SERVICE BULLETIN

T I T L E : AIR CONDITIONING - AIR COOLING SYSTEM - INSPECT RAM AIR OUTLET

Herewith Revision No. 2 of Service Bulletin A320-21-1057.

SERVICE BULLETIN No.: A320-21-1057

Flow Chart Figure 1

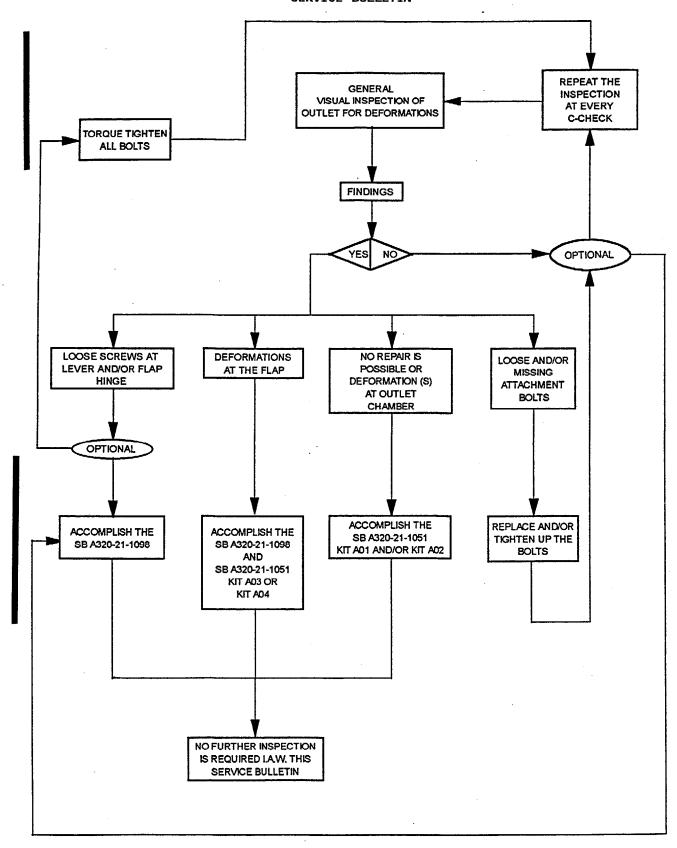
- Flow Chart amended

Refer to Figures 1 and 2

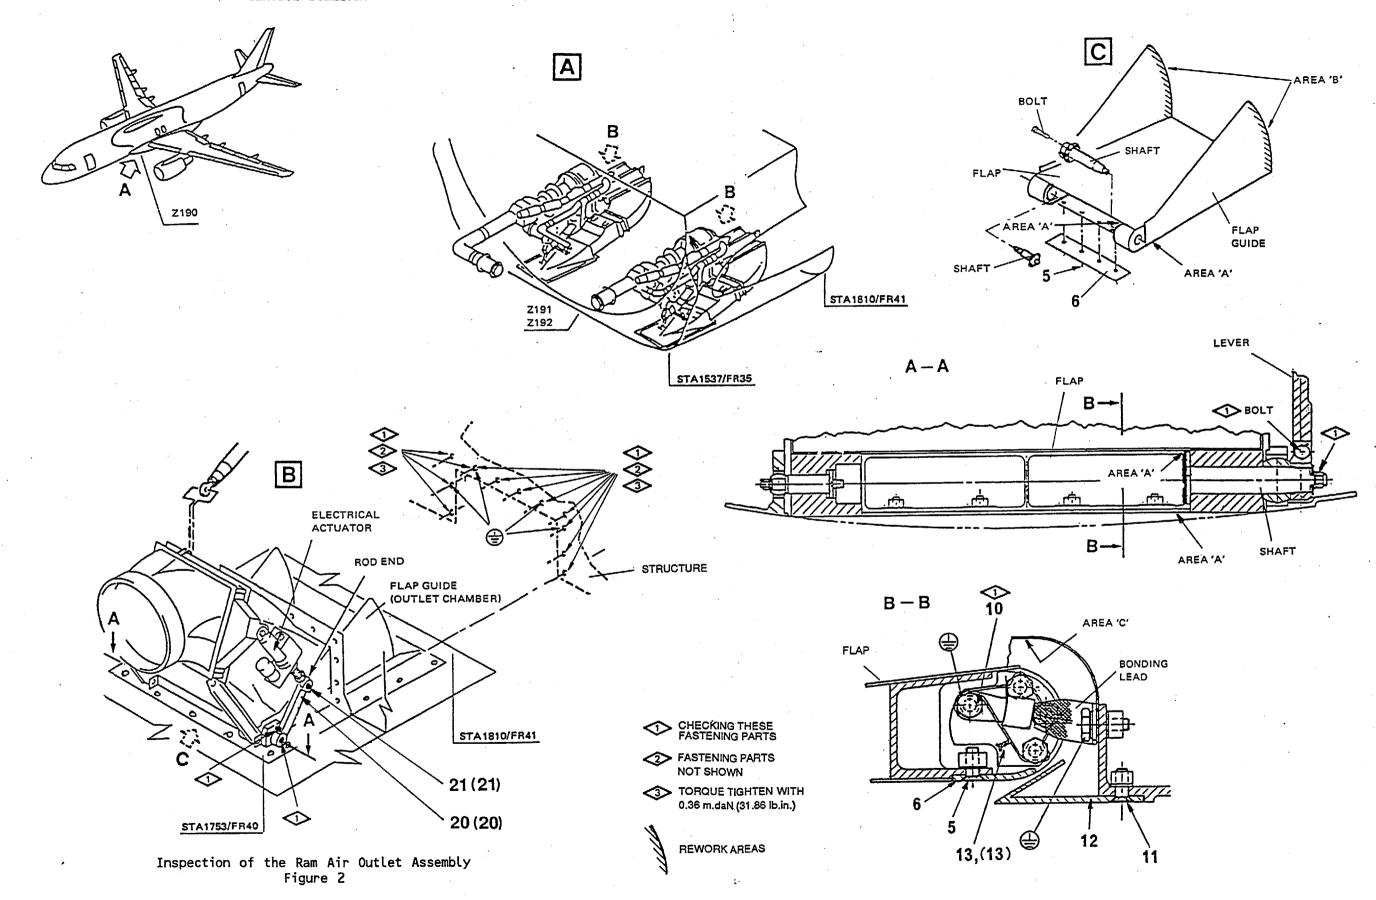
- (1) Inspect the fastening bolts of the assembly
  - (a) Inspect the fastening bolts, position shown in figure 2, detail B:
    - ensure that there are eleven bolts with washers. If not, replace bolt(s) and washer(s) in accordance with the IPC 21-61-03.

- torque tighten all bolts to 0.36daNm (31.86 lb.in.)
- (2) Check the backlash of the flap lever:
  - If backlash exists between the flap lever and shaft and if the torque of the bolt of the flap lever is not 0.5daNm (44.24 lb.in.), torque tighten all bolts or accomplish the Service Bulletin A320-21-1098 or Service Bulletin A320-21-1051 and A320-21-1098.

- (c) Rework the flap as follows only if interference is noticed:
  - 1 Remove approx. 2 mm (0.08 in.) from the contour of the flap edges (areas 'B').
  - 2 Renew the painting.

- (d) Inspection of the outlet flap for deformation.
  - 1 Inspect the areas 'A' and 'B' shown in detail C and section A-A, for mechanical deformation:
    - In case of findings at the outlet flap (area 'A' and 'B') accomplish the Service Bulletin A320-21-1051.

- (e) Inspection of the outlet chamber for deformation.
  - 1 Inspect the area 'C', shown in section B-B and the flap guide area at the outlet chamber for mechanical deformation:
